Product Change Notification

Date Issued :	November 08, 2022	PCN Number :	512754
Reason for Change :	Change Supplier		
Description of Change :	This notification is to inform you about change of supplier impacting the part(s) attached as per list, No changes will be made to product as part of this change.		
Reason for Short Notice :	Special Request		
Assessment of Change :	Supplier Qualification Test Report/s		
Planned Implementation Date :	February 19, 2023		
Sample Availability Date:	January 20, 2023		
Internal Molex Qualification Date :	February 01, 2023		
Last date to request Samples by Customer :	January 31, 2023		
Traceability Code Markings / Date :	Date code

- 105162 series add alternative copper material "C5210-SH".
- Change reason: The increasing global demand has caused a global shortage of various metal. This extraordinary situation, in conjunction with an already constrained market, has caused immediate and severe disruption in the industry. Due to these supply constraints, Molex identified an internal shortage of metal supply which would create a challenge to fulfill all orders. Therefore, we identified an alternative sourcing for the product families listed above. Aft

Before change:

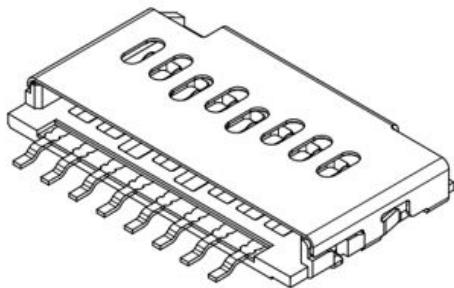
- series Add alternative copper material " C5210-SH".
 Before change: "C5240-EH"
 After change: "C5240-EH" or "C5210-SH"

1. MATERIAL: PHOSPHOR BRONZE HYPER C5240-EH,
 THICKNESS: 0.12mm.

1.Material:
 a.Phosphor bronze hyper C5240-EH ,T=0.12mm.
 b.Phosphor bronze C5210-SH, T=0.12mm.
